EXHIBIT NO. 71-030

Presentation by Jon Gerrard, MLA River Heights to the Clean Environment Commission re Sia Silica Sand Extraction Project
Pete Grewer
(Commission Secretary)

Saturday, March 11, 2023

Fig 1. Within a well extraction site. The “angle of repose” of the sand is too shallow to allow for a “pillar” to develop between extraction sites. Assuming a well depth of 10m below the shale aquitard, the sand will leave a gap of 3 meters at its highest point.

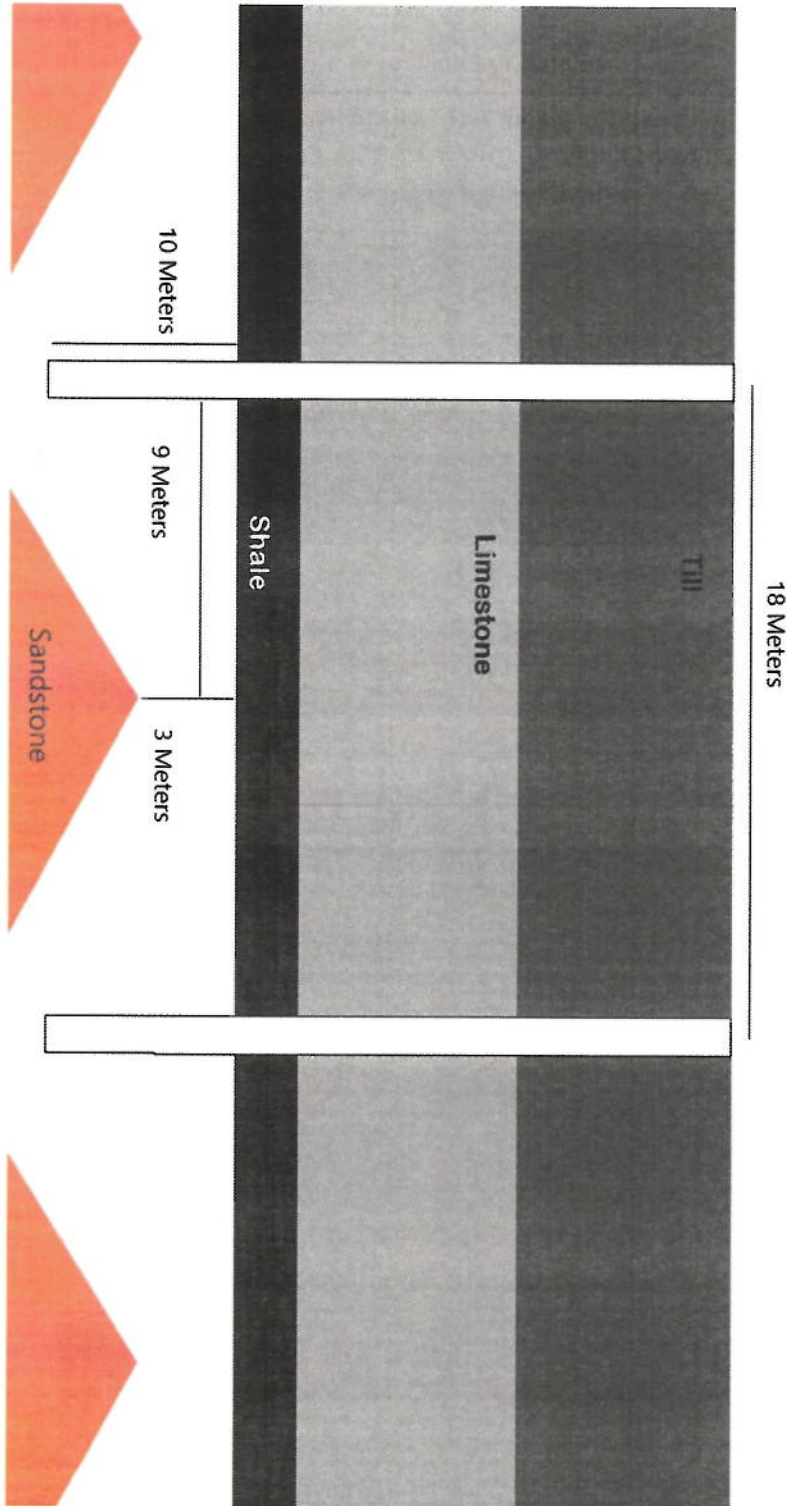
“pillar”. However, the proposal is for extraction sites which are 18m apart. Under these conditions, the sand is unlikely to be able to form an adequate pillar (Fig 1). The results of not forming an adequate pillar are several and include -intermixing of the waters of the two aquifers and subsidence of the ground above the extraction site(s). The company is planning to operate up to 467 extraction wells annually.
